**BEFORE THE INDEPENDENT HEARING PANEL
FOR THE QUEENSTOWN LAKES PROPOSED DISTRICT PLAN**

Under the Resource Management Act 1991
In the matter of the Urban Intensification Variation to the proposed
Queenstown Lakes District Plan

**REBUTTAL EVIDENCE OF CAMERON WALLACE
ON BEHALF OF QUEENSTOWN LAKES DISTRICT COUNCIL**

URBAN DESIGN

Figure 1 - Model Shot at 1.30pm on 21 July showing the notified theoretical bulk (top) against the recommended changes by the submitter for 10 Man Street (bottom in pink)

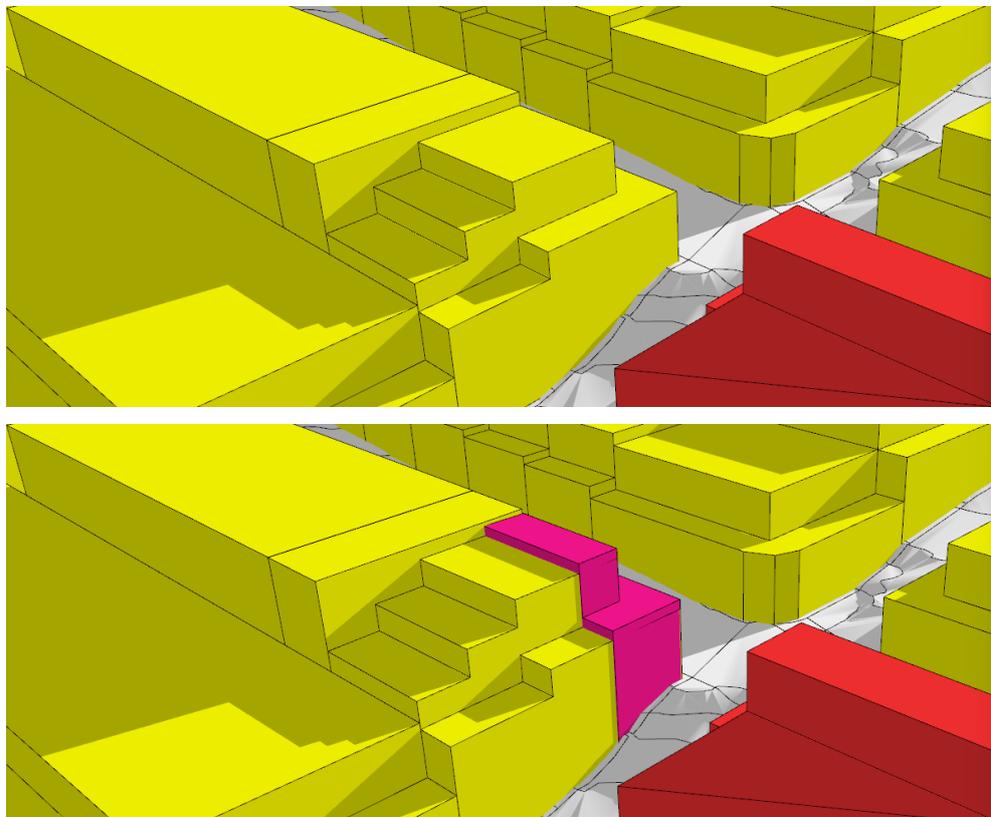
6.6 Having considered the evidence of Ms Costello, I have undertaken additional 3D modelling in line with Figure 4 of my EiC. An excerpt of this is shown in Figure 1 below with the additional bulk shown as a result of the requested relief shown in pink. In my opinion, any impact associated with this change is low-to-negligible in terms of potential urban design effects, noting that any future development would remain subject to a resource consent process. As such, I concur with Ms Costello and could support an amendment in line with her recommendations.
